American Railway Engineering and Maintenance of Way Association

Letter Ballot 07-23-09

Proposed changes as follows:

Figure 7-G-1. Example of Corbel Block

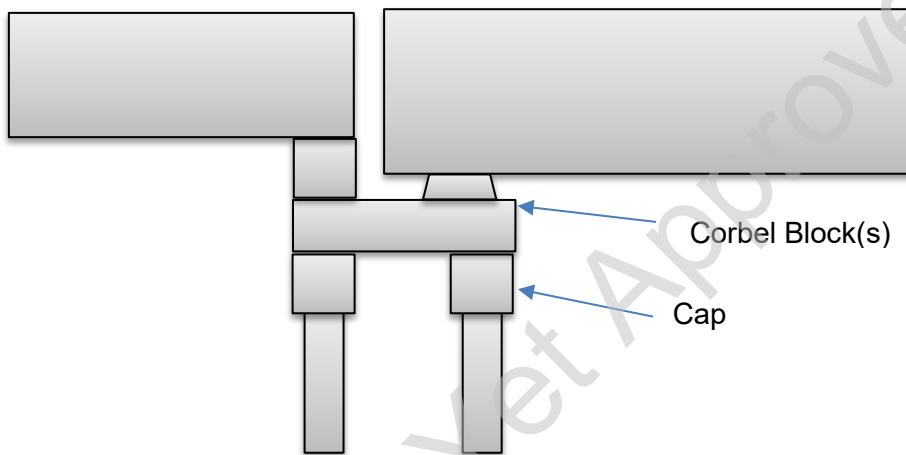
Add Definition to Glossary Item 3. Terms, as follows:

Corbel Block(s) - Timber blocks placed in horizontal orientation intended to distribute the load to adjacent rows of piles or other substructure components.
